From: Karen Garner on behalf of Planning.Responses
Sent: 25 July 2012 10:56
To: Siobhan Honney-Bayes
Subject: FW: EP/70/12. Sandgate House.
Attachments: scan0001.jpg; scan0002.jpg; Sandgate House Plans.doc

Mr & Mrs S. Williams
Spindrift
South Strand
East Preston
BN16 1PN

Ref EP/70/12

South West View

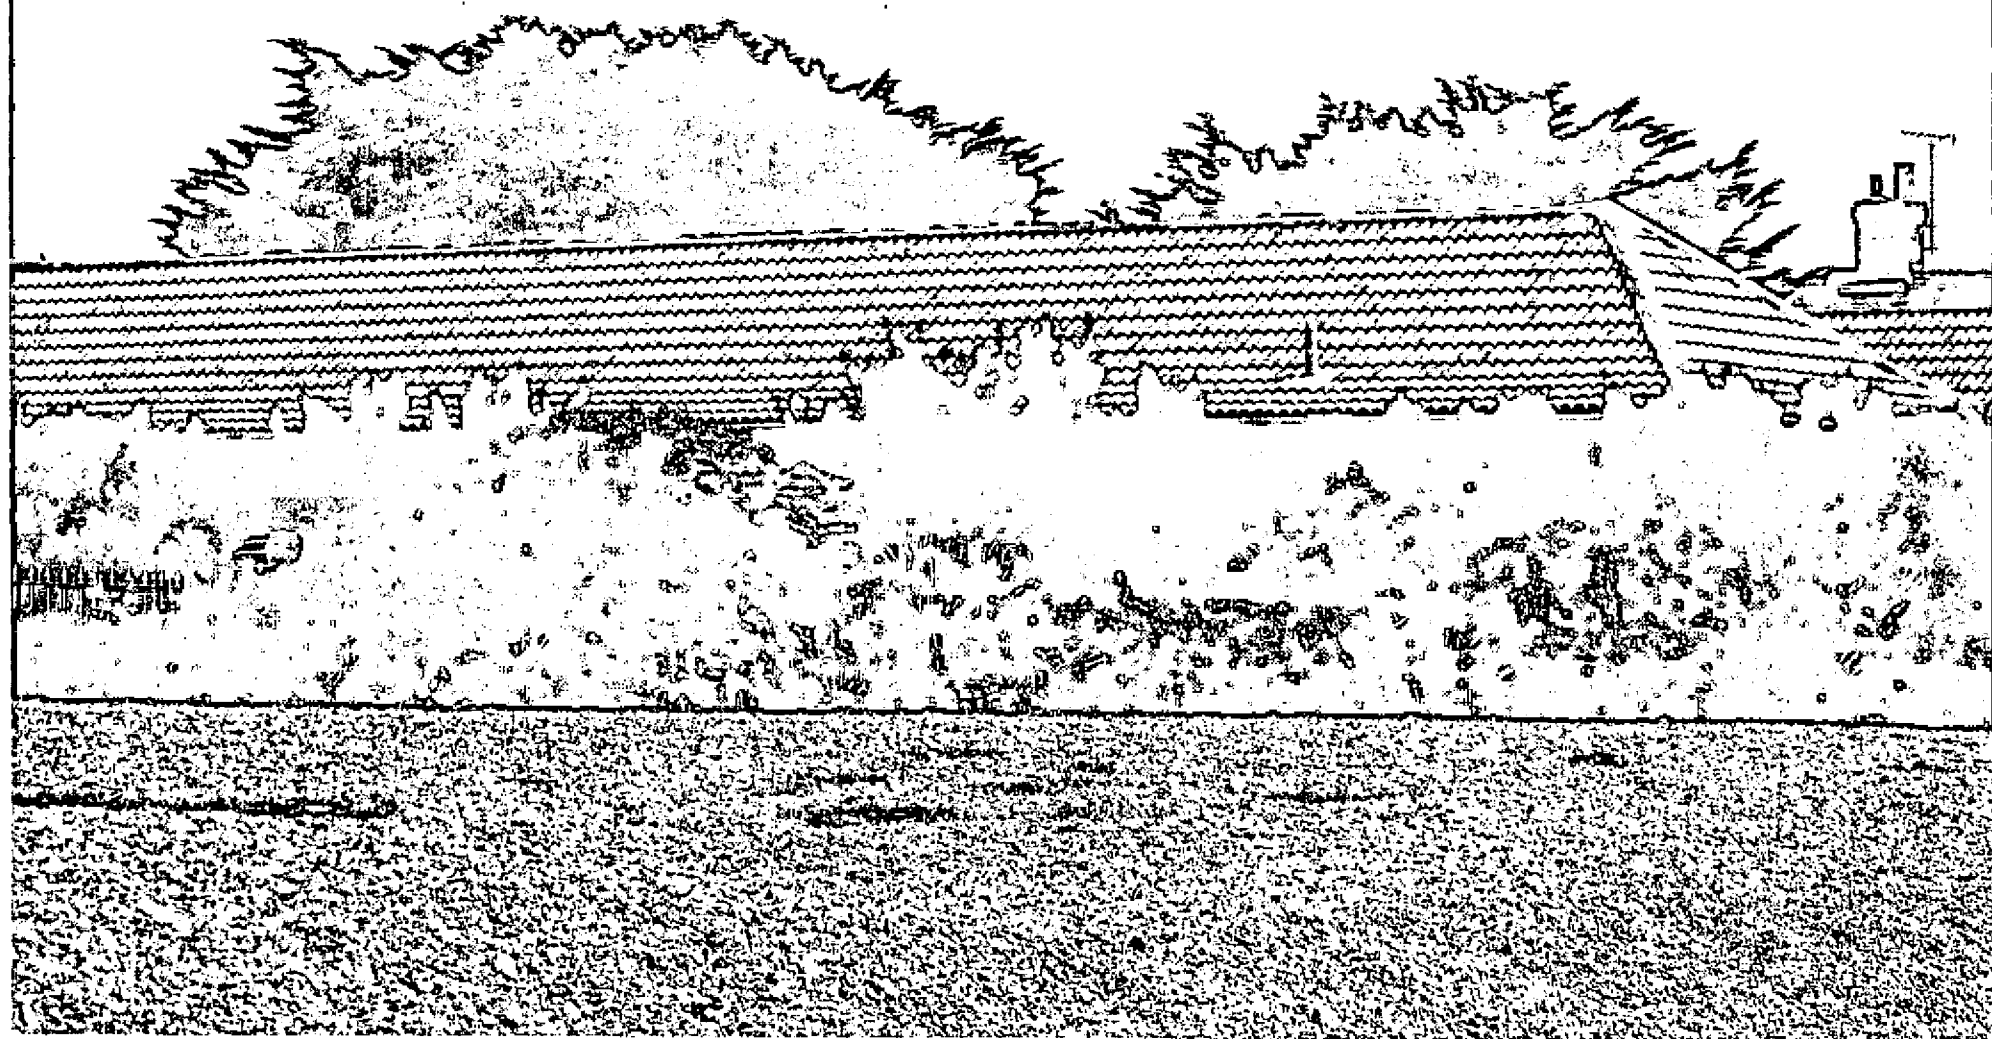
Historically, with regards to other applications in this area, planning has sought to maintain the low level, ground floor level beach scene which runs from the sailing club to past Sandgate House, all with pitched roofs. The nature of the proposed design, which allows for a new raised structure on the west and south west corner would take the existing height from 2.6m on the west side rising away at a pitched angle to 4.4m in overall height, to a new solid height rising directly up on the south and west side to 6.2m. This flat roof structure at 6.2m rises back along the west elevation for 10.6m and provides a mass that is heavy and imposing to the beach scene and other properties (both behind and to the side).

The application (conclusion in DAS) is extremely light in its emphasis on this first floor structure and skirts over it. It is also noted that the beach scene montage, while itself a useful document, is taken from the South East (a number of properties along to the east of Sandgate) and therefore projects a reduced impact when it looks back at Sandgate House. This scene is also not the same as the photo model visualisation which, with the removal of the greenery, makes the house more prominent and imposing. Due to the fact that Sandgate sits at a south east angle on its plot the proposed introduction of this first floor from the south beach scene, south west and west is very marked. This has not been shown in the plans.

Attached to this letter are two photos of the beach scene from the South West, one as existing and one very crudely showing the impact of the new structure.
